HISTORIC PRESERVATION BOARD

HISTORIC PRESERVATION BOARD MEETING

**PUBLIC HEARING
58 FORE STREET (former Portland Company Complex)**

TO: Chair Sheridan and Members of the Historic Preservation Board
FROM: Deb Andrews, Historic Preservation Program Manager
DATE: January 31, 2019
RE: February 6, 2019 PUBLIC HEARING

DRAWING NO.
C-10

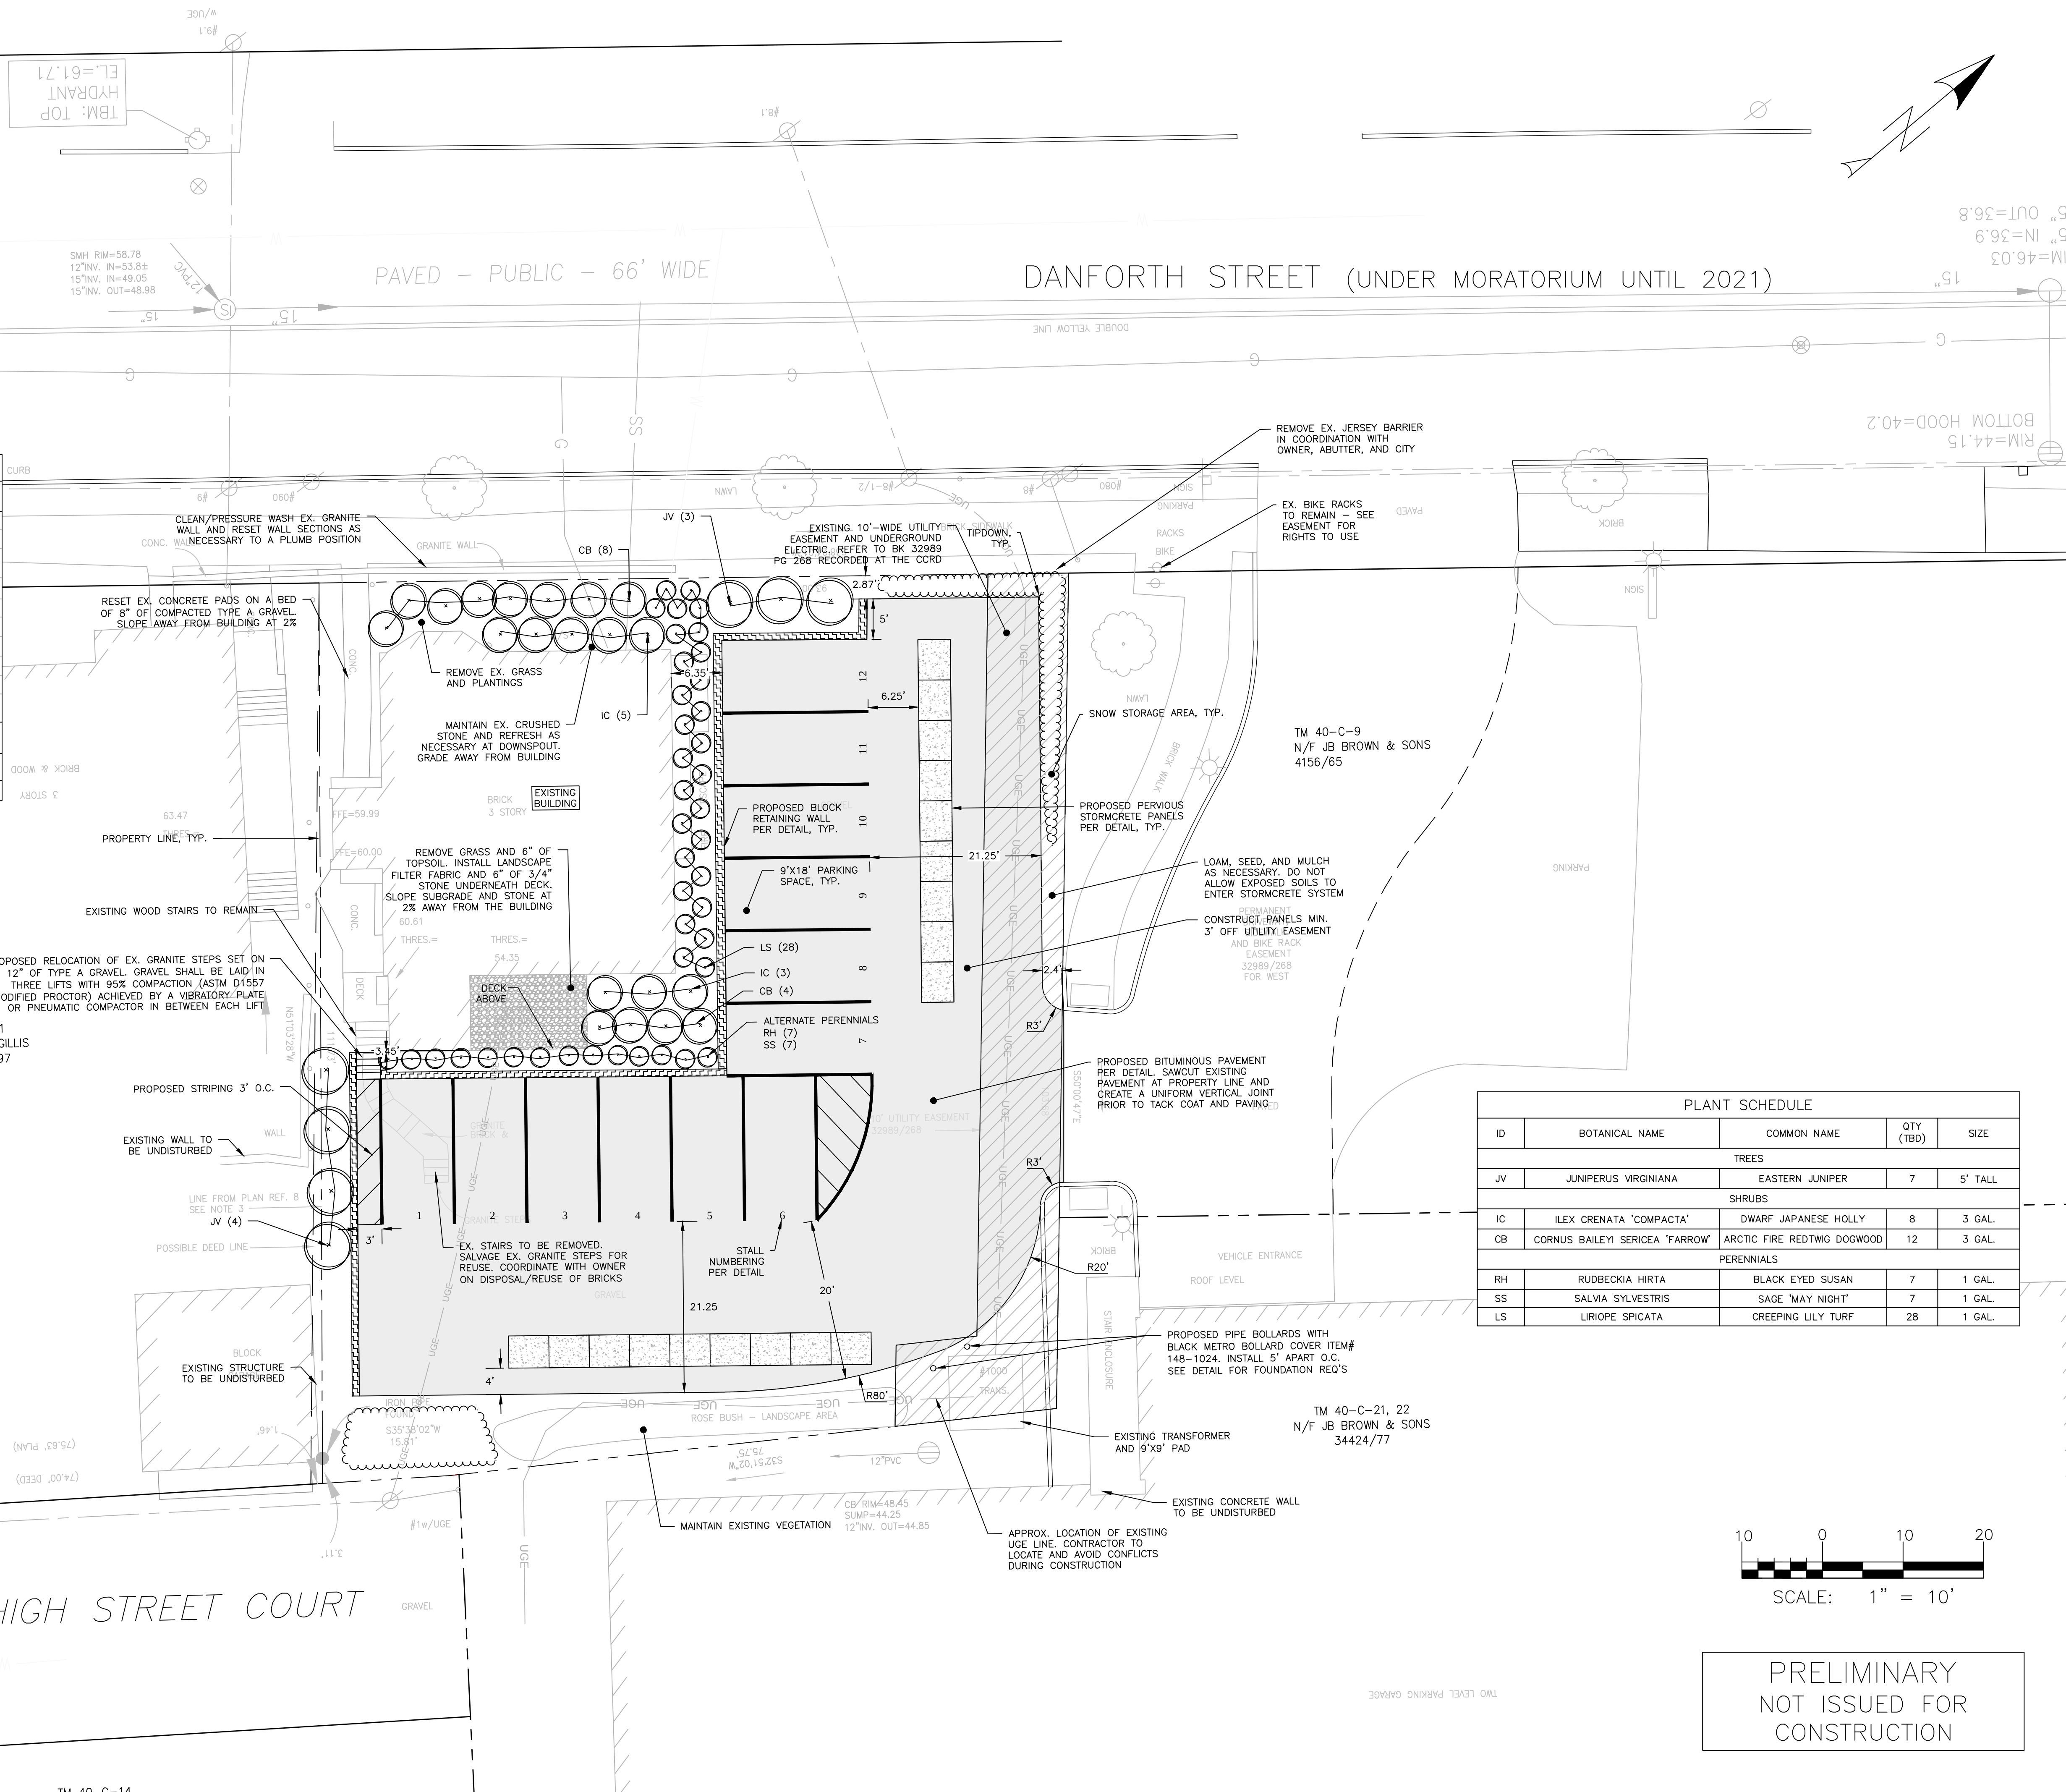
- Staff is aware that the distance from the east side of the building to the east boundary constrains the amount of space between the parking and the foundation. If it were possible to move the retaining wall further from the building it would soften the effect, but the size of parking spaces and a minimal turning aisle leave little room for adjustment – only a narrow buffer for grass and snow storage is planned at the eastern boundary.

- Staff wonders if twelve parking spaces are really necessary. Even reducing the number by one (or more) could make more landscaping and screening possible along Danforth Street.
